#### **MEMORANDUM**

Subject: Supplemental Analysis and Findings of Fact for the American Exchange, Block 101 (1

#### **TECHNICAL MEMORANDUM**

Subject: American Exchange, Block 101 (1 N Pinckney St), Madison, WI City Plan and Code

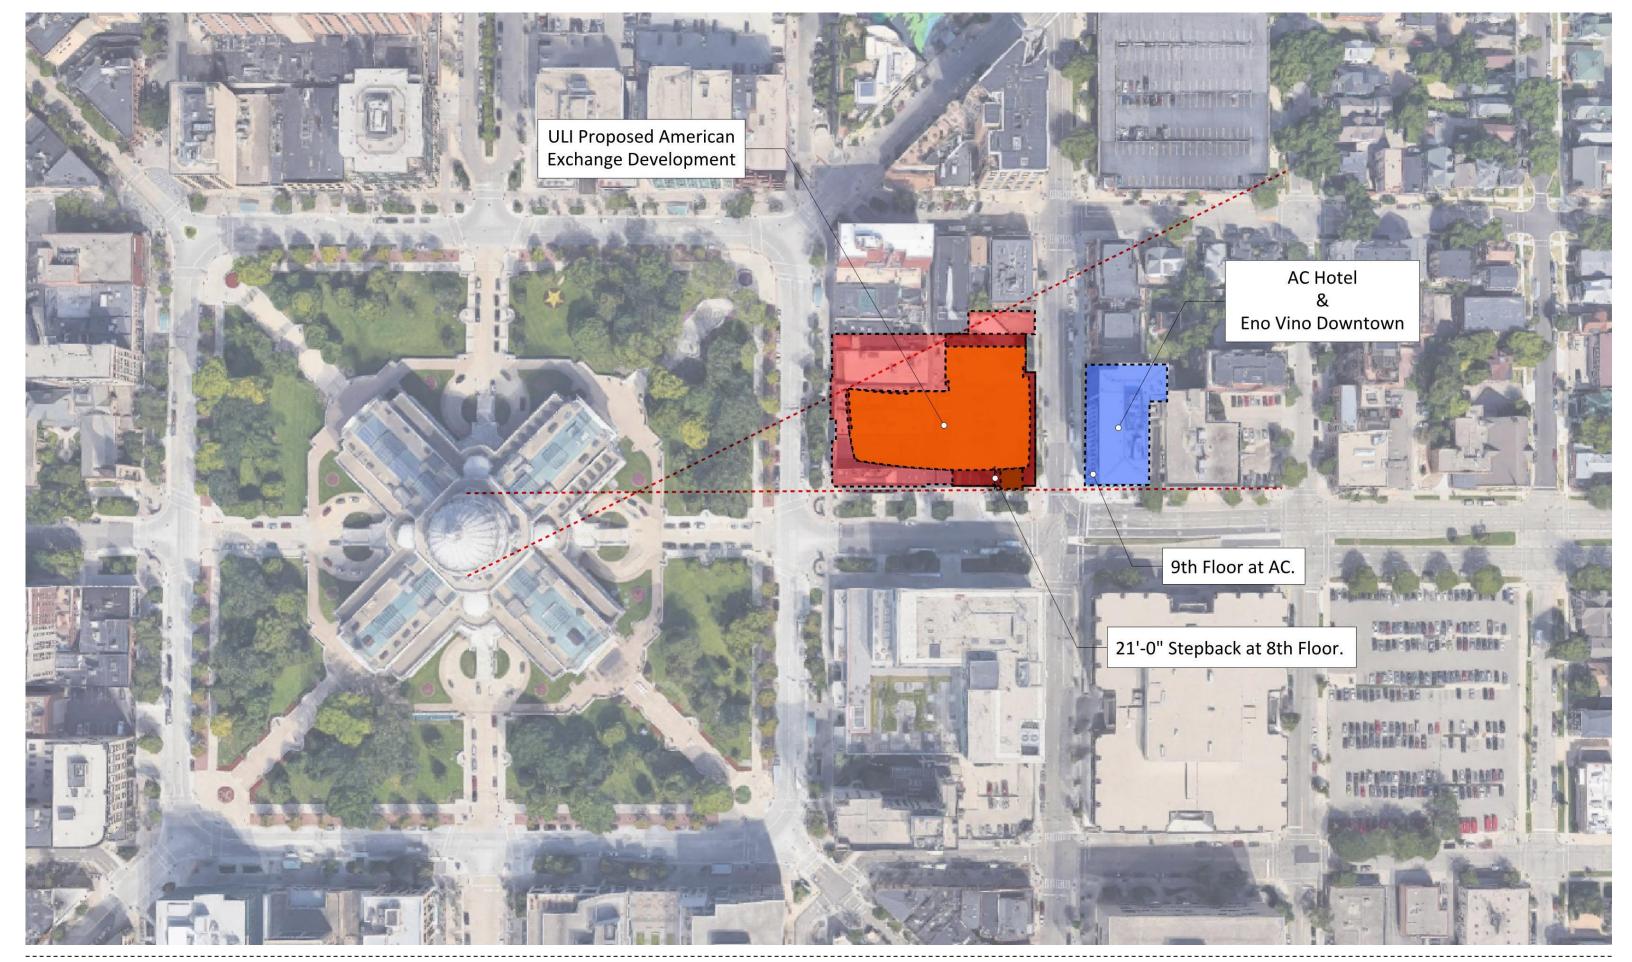
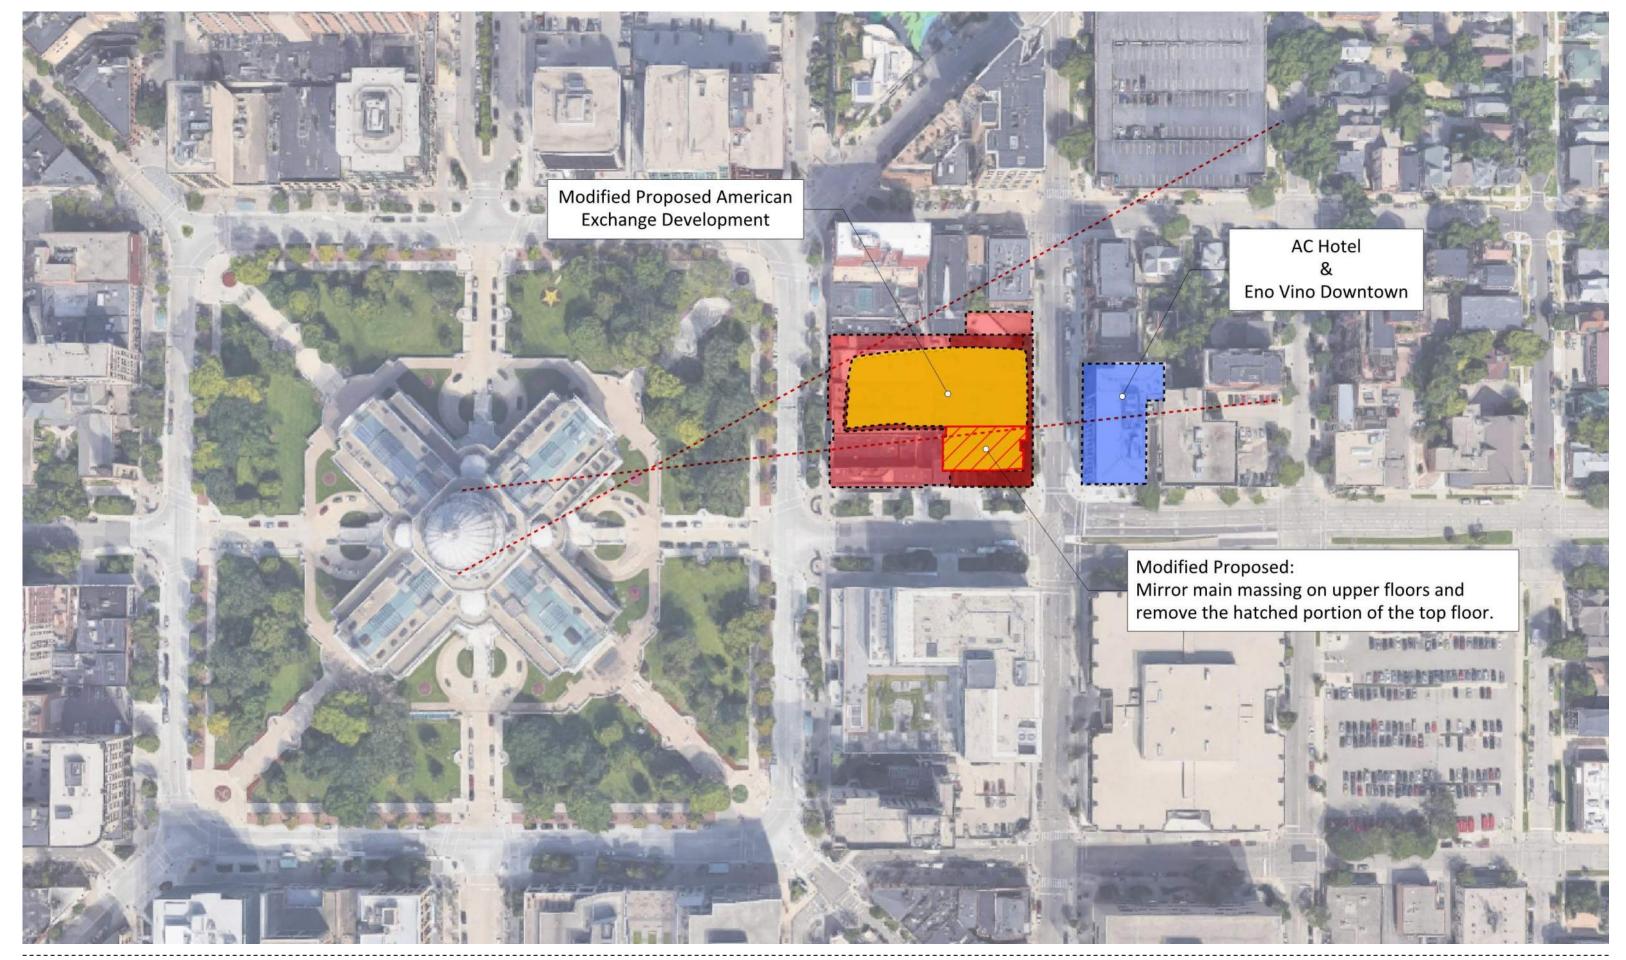
Analysis: ULI failed to coordinate the architectural massing to achieve compatibility with the neighboring properties. The current ULI proposal includes an approximately 80 foot mass up to and actually encroaching several feet beyond the ULI property line into the City owned East Washington Ave. Right-of-Way. The upper approximately 20 feet of the East Washington Ave. façade does have a modest (approximately 20 foot) step-back from the East Washington Ave. right-of-way/property line and continuing up to the Capitol Height Limit. The mechanical screening on the roof extends another 12 feet above the Capitol Height Limit and, while not dimensioned, the elevator over-run extends several feet above the mechanical screening. The result of this massing is to obstruct most of the public view of the Capitol Dome from the AC Hotel and Eno Vino Downtown (as illustrated with the red and yellow shading on the

Figure to the right) except for the few views closest to the East Washington Ave. elevation (as illustrated with the tan shading on the same Figure). As demonstrated in the Technical Review Memorandum dated October 19, 2020, and as concluded by GBA, a Wisconsin licensed architect well versed in the City of Madison zoning standards, the ULI proposal as currently designed will substantially depreciate, adversely impact, diminish and impair the uses, values, and enjoyment of property.

The current ULI proposal includes an approximately 80 foot mass up to and actually encroaching several feet beyond the ULI property line into the City owned East Washington Ave. Right-of-Way. The upper approximately 20 feet of the East Washington Ave. façade does have a modest (approximately 20 foot) step-back from the East Washington Ave. right-of-way/property line and continuing up to the Capitol Height Limit. The mechanical screening on the roof extends another 12 feet above the Capitol Height Limit and, while not dimensioned, the elevator over-run extends several feet above the mechanical screening. The result of this massing is to obstruct most of the public view of the Capitol Dome from the AC Hotel and Eno Vino Downtown (as illustrated with the red and yellow shading on the Figure to the right) except for the few views closest to the East Washington Ave. elevation (as illustrated with the

tan shading on the same Figure). Accordingly, GBA concluded that the ULI proposal as currently designed will substantially depreciate, adversely impact, diminish and impair the uses, values, and enjoyment of property.

Under the proposed ULI Development, there will be a great impact to the Capitol view from the AC hotel. The ULI Development will block approximately 75% of the building from having any view of the Capitol dome. 15% of the building will suffer a partial blocked view of the dome, and 10% will have a partial blocked view of the Capitol overall.

With the Proposed Modification to the ULI Development, the large impact to the Capitol view from the AC hotel with be reduced. The proposed modification will allow a majority of the 9th and 10th floors of the AC and Eno Vino to have full Capitol Dome views. The full impact to the Capitol Dome is reduced by approximately 24%, with a majority of this percentage shifting to allow for more full Capitol Dome views.

GBA also evaluated the feasibility of incorporating modifications to the ULI proposal based on recommended design improvements from UDC Commissioners during the ULI informational presentation at the May 27, 2020 Urban Design Commission meeting. Specifically, GBA evaluated the feasibility of mirroring the office tower and decreasing the height modestly along the East Washington Ave portion of the office tower as shown on the two figures on the following page. The results of this feasibility analysis determined that the ULI design can be modified to: a) preserve approximately the same density (300,000 SF) in the current ULI development proposal, b) accommodate a similar structural grid as the current ULI proposal, c) incorporate ULI's desired first and second floor uses with modest reconfiguration, and d) not significantly modify the ramping or number of parking stalls

incorporated into the subterranean parking. Significantly, as illustrated in the Figure to the right, the feasibility analysis demonstrated and GBA concluded that the ULI proposal can in fact be modified to not
